| Procedure: SID HORTO (RNAV) THREE WASHINGTON DC KDCA | | Enroute: YES | Specialist: Moore, Frank | | Agreement Number: |

| FIPC DME/DME FORM | | | | | | |
|---|---|----------------------------------|--|-----------------------------------|--|--|
| PROCEDURE: SID HORTO (RNAV) FOUR WASHINGTON DC KDCA | | | AIRPORT NAME: RONALD REAGAN WASHINGTON | | AIRPORT ID: KDCA | SPECIAL CONTROL NO: YG-09-141-20 |

1. FLIGHT PROCEDURE IDENTIFICATION:

Subject: Approval Request: Ronald Reagan Washington National, DC (KDCA) HORTO DEPARTURE (RNAV),

HORTO THREE DEPARTURE(RNAV)

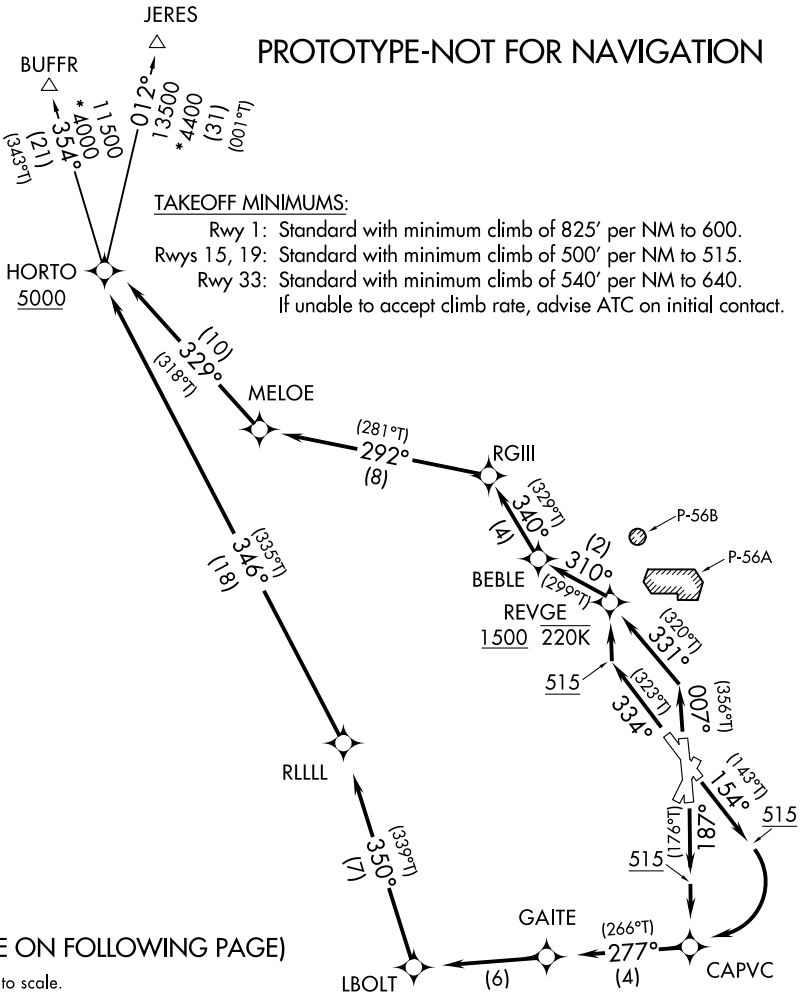
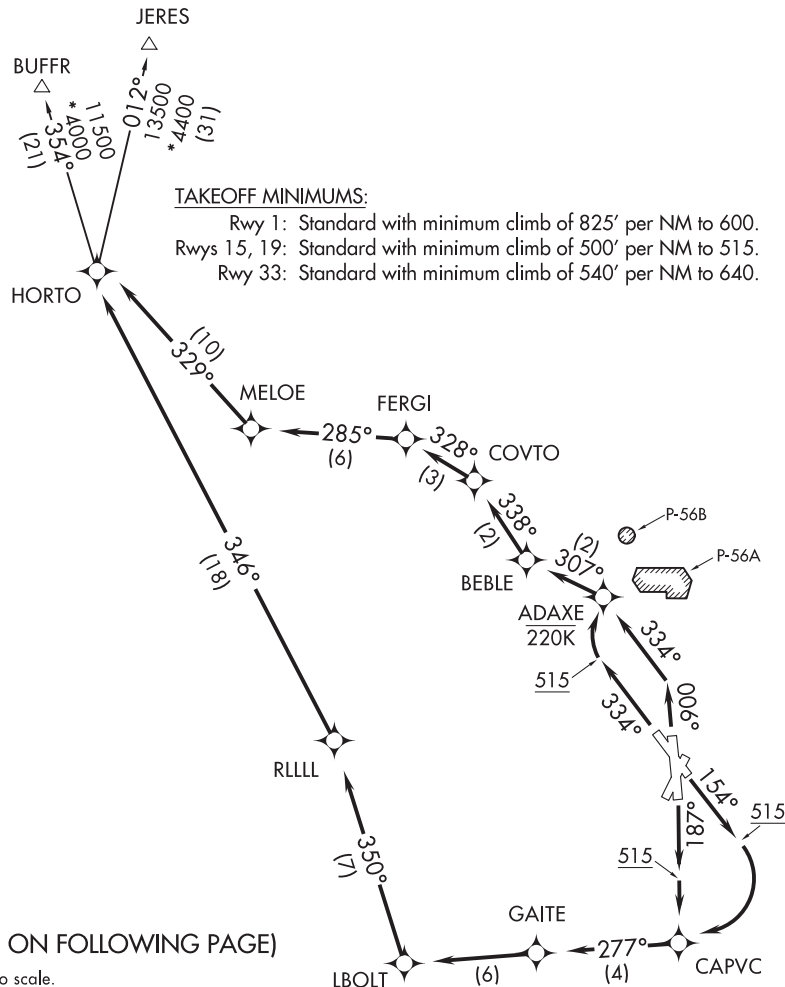
| <p>Procedure Comments: ACTIVE DATA USED FOR KDCA DEPARTURE DEVELOPMENT. ATC REQUESTED CHANGES. APPROVAL LETTER FOR CLIMB GRADIENT. WAIVER FOR LENGTH OF SEGMENT. CONTACT DAVE TEFFETELLER AT 202-267-5177.</p> <p>05/19/20: THIS IS AN UPDATED COPY OF THE FORM DEVELOPED ON 02/13/20. 1. ADDED NOTE: TURBO-JETS ONLY. 2. UPDATED RGIII COORDINATES FROM 355800.54N/0770848.38W TO 385800.54N/0770848.38W .</p> <p>10/22/20: THIS IS AN UPDATED COPY OF THE FORM DEVELOPED ON 02/13/20. 1. CHANGED RWY01 VI LEG DIST FROM 1.79 TO 1.61</p> | | | | | |

- NOTE: RNAV 1.
NOTE: RADAR required.
NOTE: DME/DME/IRU or GPS required.
NOTE: Departing Rwy 1 requires expeditious intercept of outbound course to ensure avoidance of P-56 boundary.
NOTE: Rwy 1 departures remain clear of P-56, climb on heading 006°, turn left as soon as practical to intercept course 331° to REVGE.
NOTE: Pilots shall comply with Ronald Reagan Washington National Airport noise abatement and prohibited area (P-56) avoidance procedures as defined in the Chart Supplement special notices.

TAKEOFF RWY 1: Climb heading 007° to intercept course 331° to REVGE, cross REVGE at or above 1500 and at or below 220K, then on track 310° to BEBLE, then on track 340° to RGIII, then on track 292° to MELOE, then on track 329° to HORTO, cross HORTO at or above 5000, thence

NOTE: RNAV 1.
NOTE: RADAR required.
NOTE: DME/DME/IRU or GPS required.
NOTE: Departing Rwy 1 requires expeditious intercept of outbound course to ensure avoidance of P-56 boundary.
NOTE: Rwy 1 departures remain clear of P-56, climb heading 006°, turn left as soon as practical to intercept course 334° to ADAXE.
NOTE: Pilots shall comply with Ronald Reagan Washington National Airport noise abatement and prohibited area (P-56) avoidance procedures as defined in Airport/Facility Directory special notices.

TAKEOFF RWY 1: Climb heading 006° to intercept course 334° to ADAXE, then on depicted route to HORTO, thence

Figure 1: The no action alternative flight radar tracks (light blue) versus the proposed actions flight radar tracks (magenta) for the period January 30 - February 5, 2020.

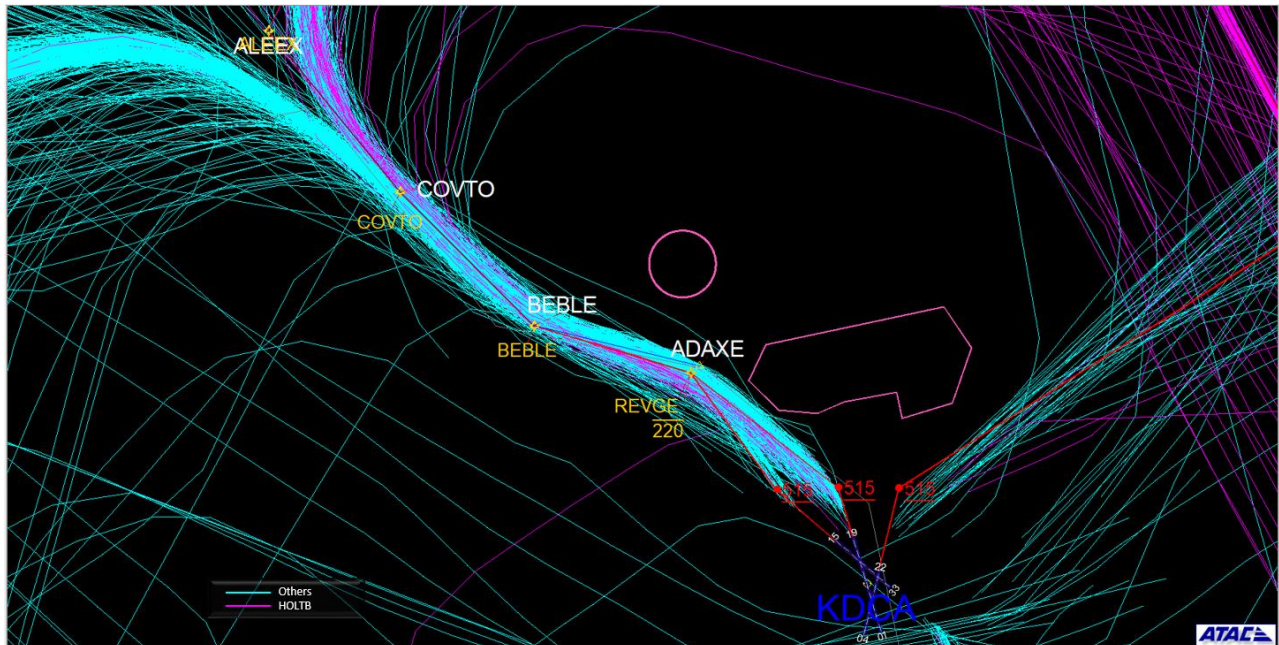
- 1) The following procedures would be amended to replace waypoint ADAXE with REVGE: HORTO4, CLTCH3, JDUBB4, SOOKI5, DOCTR5, REBLL5, WYNGS5, SCRAM6. Refer to **Figure 1**
- 2) In addition to action 1, the following procedures would also replace waypoint FERGE with RGIII: HORTO, WYNGS, REBLL, CLTCH, SCRAM, and JDUBB. Refer to **Figure 2**
- 3) HOLT B1, which was initially adopted for temporary use through July 31, 2020, will be adopted for continued use until it is replaced by AMEEE1, as described below.
- 4) The AMEEE1 procedure will be published and replace the HOLT B1 and BOOCK3, which will be canceled. Refer to **Figure 1**
- 5) To enhance safety and efficiency into the NEC and ACR, the BWI CONLE SID and IAD JCOBY SID will be amended to incorporate the SCOOB transition for aircraft over 18,000 feet AGL. Refer to **Figure 3**

The need for this project is to enhance national security by reducing incursions into P-56 airspace. The shift from waypoint ADAXE to REVGE is expected to reduce incursions by causing aircraft to turn away from P-56 sooner to fly-by waypoint REVGE, which will be located 784 feet southwest. This action was requested by the U.S. Secret Service, which asked the FAA Administrator to formulate a solution to protect the P-56 airspace. This proposed change will affect multiple north-flow aircraft departure procedures, which would replace waypoint ADAXE with REVGE.

Figure 2: Flight tracks (blue lines) using FERGI waypoint. The dark blue line is the existing route using the FERGI waypoint. The red line is the proposed route removing FERGI and adding RQRI waypoint. Flight tracks were recorded in August 2019.

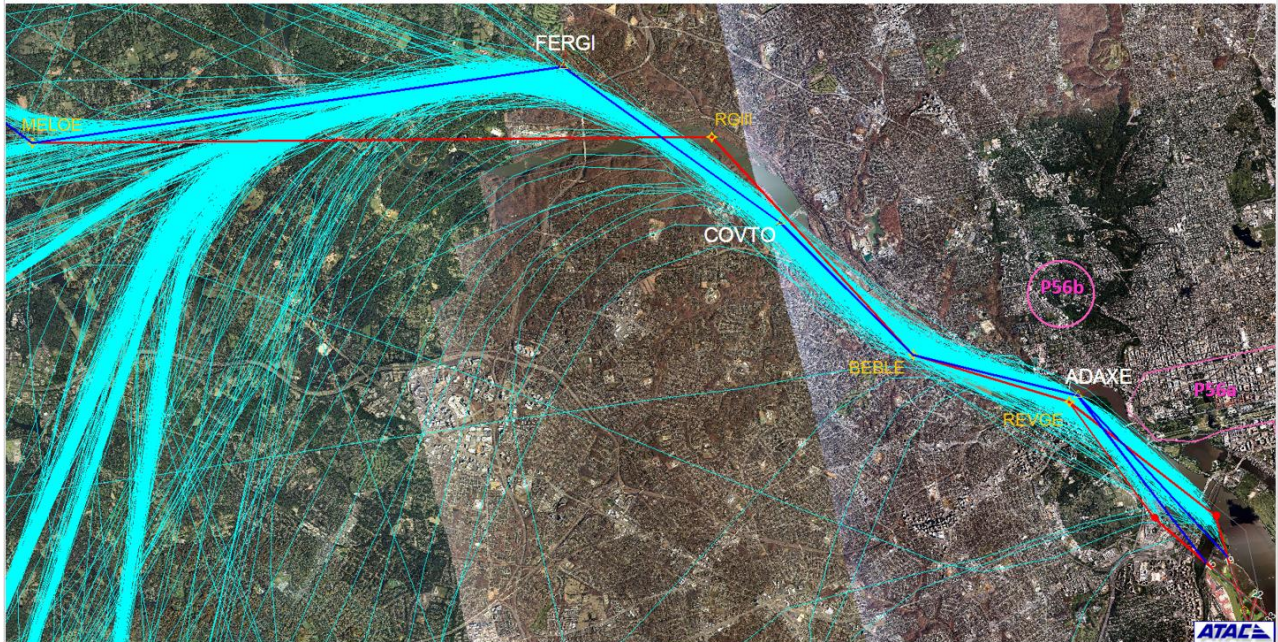
Additionally, the FAA is proposing to remove waypoint FERGI and replace it with a new waypoint, RGIII, which will keep aircraft closer to the Potomac River. The change was requested (following a unanimous vote) by the DCA Community Noise Working Group, a group comprised of representatives from surrounding communities that is focused on noise-related concerns from aircraft operating at DCA. The FAA opened a comment period from May 15, 2020 to June 15, 2020 to allow the public the opportunity to comment on the FERGI waypoint removal; establishment of the AIMEE SID; cancellation of HOLTB and BOOCK SIDs; and, establishment of the the high altitude SCOOB transition. The FAA received three comments which can be reviewed in **Attachment C**. Refer to **Figure 2** to view flight tracks for the removal of waypoint FERGI and the addition of RGIII.

The removal of waypoint FERGI and incorporation of a new waypoint, RGIII, will increase efficiency by shortening the north flow departures by 0.2 nautical miles and implement procedure changes requested by the Reagan National Community Noise Working Group. The need for this project was identified by the Reagan National Community Noise Working Group, which voted unanimously to request that the FAA implement the change.

Figure 3: Flight tracks (light blue lines) near the proposed SCOOB transition (blue line). Flight tracks were recorded in August 2019.

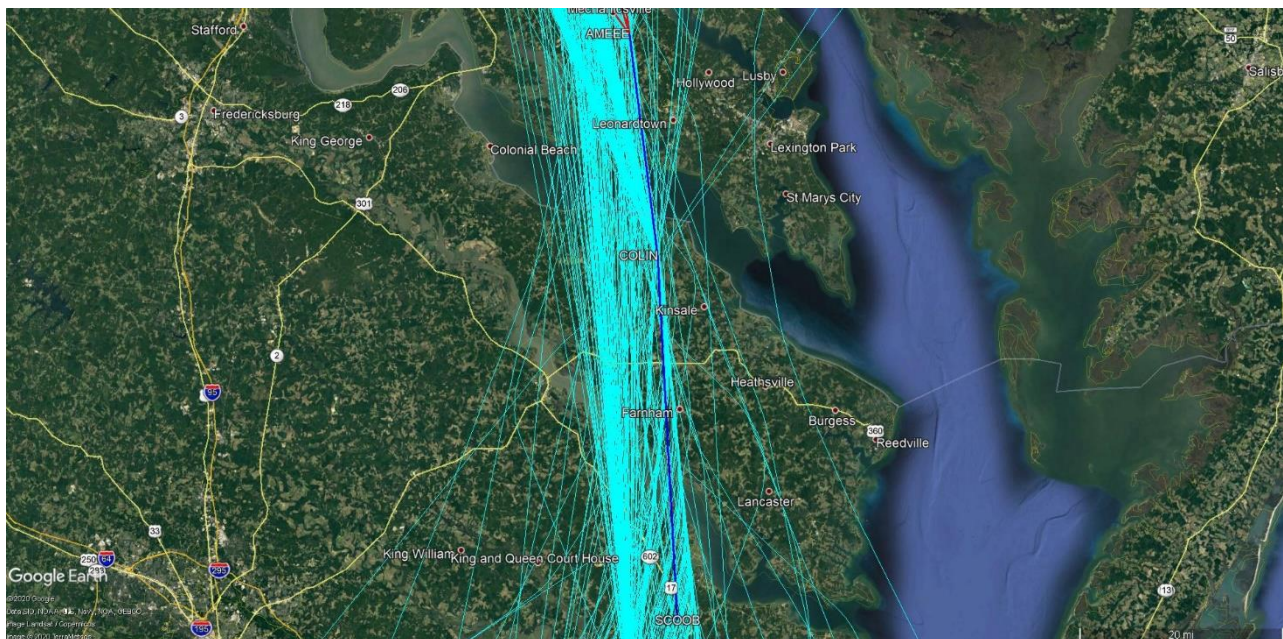
The BWI CONLE and IAD JCOBY SIDs are being amended to establish the SCOOB transition, as proposed for the new AMEEE1, which will be used above 18,000 feet AGL and is not expected to change the existing flight corridor. Refer to **Figure 3** to view the proposed SCOOB transition.

The FAA proposes to implement the SCOOB transition by extending the AMEEE (HOLTB/BOOCK replacement procedure) enroute transition beyond waypoint COLIN to SCOOB. This action also requires amending the Baltimore Washington Airport (BWI) CONLE SID and Dulles Airport (IAD) JCOBY SID, which share the same track. The SCOOB transition will be used for aircraft flying over 18,000 AGL. Refer to **Figures 1, 2, and 3** to view the proposed route changes and existing flight tracks for aircraft that will use the proposed procedures.
